## **ROTORUA DISTRICT PLAN**

### **Proposed Plan Change 2 Pukehāngi Heights**

### **S42A PLANNING REPORT**

**Hearing Date: 17 February 2020**

*Figure 2 Pukehāngi Sensitive Rural Area, 2012 Caldera Rim Report (yellow boundary)*

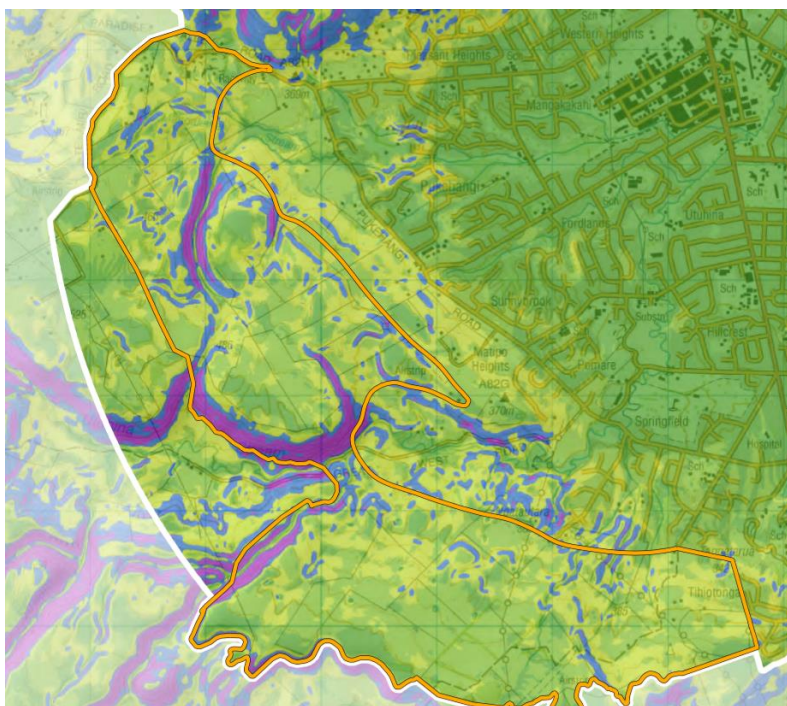
- 8.29 It is agreed with the Hunt Family that the Utuhina Valley Farm’s submission seeking no development on the caldera rim lacks specificity. The plan change area lies within the caldera rim as identified in the Boffa Miskell 2012 Caldera Rim Report. However, Boffa Miskell found that the visually prominent landform does not include all of the elevated land of the caldera rim. Boffa Miskell mark the boundary between more sensitive and less sensitive areas in Pukehāngi Heights at approximately the 385m contour. The area proposed for development under the plan change provisions is, therefore, in the less sensitive area.

- 8.30 While Boffa Miskell acknowledged the less sensitive areas of the caldera rim still have important amenity values, they consider they have greater ability to accommodate change due to existing vegetation cover, lower visibility from public viewpoints and the undulating topography. Boffa Miskell considered that the lower slopes of [Pukehāngi Heights] have some ability to create connections with the surrounding residential development, however above the RL385m contour the rural character of the site should be maintained.

- 8.31 The 2019 Boffa Miskell Landscape and Visual Effects Assessment, specifically addressing the plan change area, found that confining development beneath the RL385 contour ensures the protection of the recognised broader representation of the caldera rim landscape and feature. Boffa Miskell noted that the proposed built form is consistent in geographical extent and location to that of other existing development within the caldera, including residential areas within Tihi-o-Tonga, Springfield and Lynmore, which are all located in similar proximity to the caldera rim as that of the proposed development area. It was also noted that the objectives and policies relating to the protection of the caldera rim in rural zones are limited to the area identified as sensitive.

Figure 4 Marked up structure plan showing location of original homestead

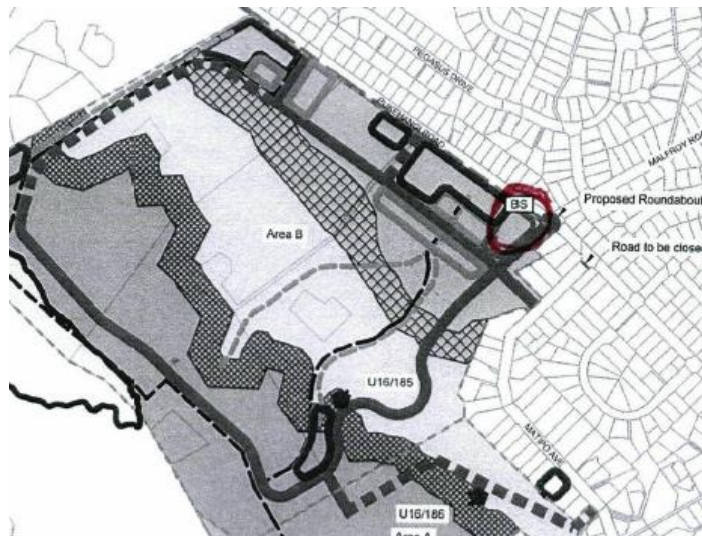
- 8.88 J van der Waals provided a marked up structure plan showing the area currently occupied by a phoenix palm where the original homestead (1919) was located. She seeks that the London plane tree (which provided shade for the stockyards) and row of Lawson cypress trees opposite Malfroy and Pukehāngi Roads intersection be protected and/or incorporated into the new development. She also seeks that the shearing shed and surrounding outbuildings are saved to preserve the heritage and history of the area for future generations (submission 45.0).

Figure 5 Proposed Medium Density Residential Area (orange hatching within orange outline).  
Red dashed line = existing boundary of plan change area.

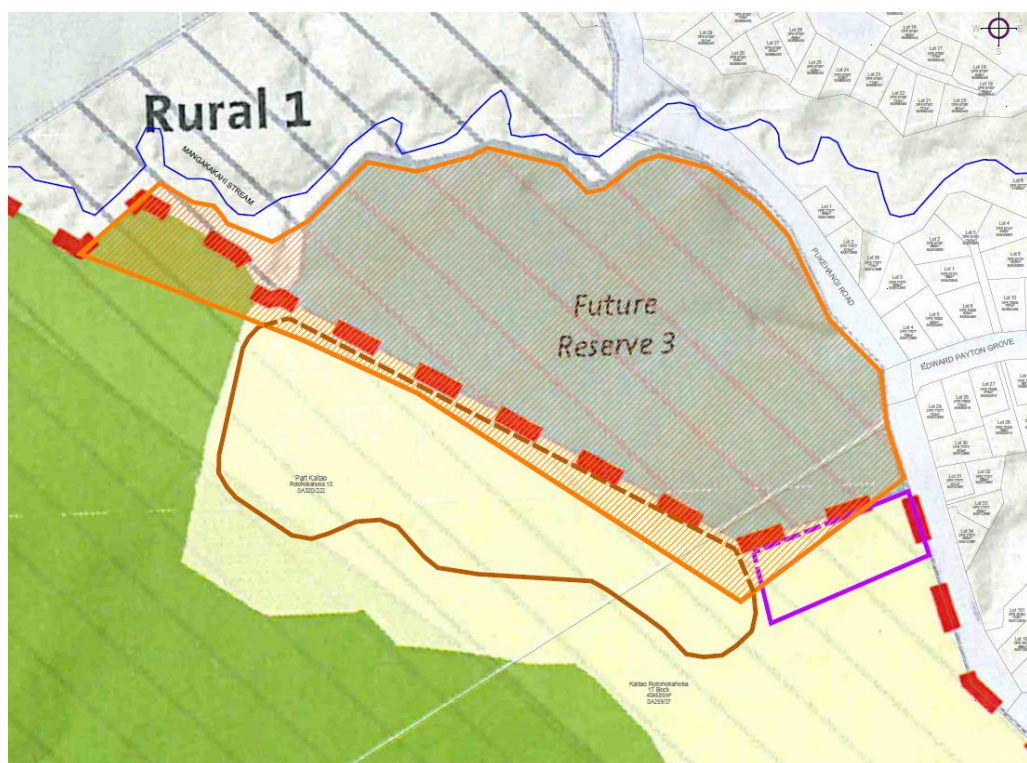
8.527 Freedom Villages, who are in the process of purchasing the site, requests that the area identified with orange hatching in the figure below be identified for medium density residential development. The majority is land outside the plan change area and currently zoned Future Reserve 3 zone. A small area inside the current plan change boundary but without the medium density notation is also included.

8.528 The submitter explains that the land was initially intended as a school, which is consistent with the current Future Reserve 3 Zone. However, as the Ministry of Education have no recorded interest in this site for a school, the submitters are now seeking provisions that enable development of a retirement village.
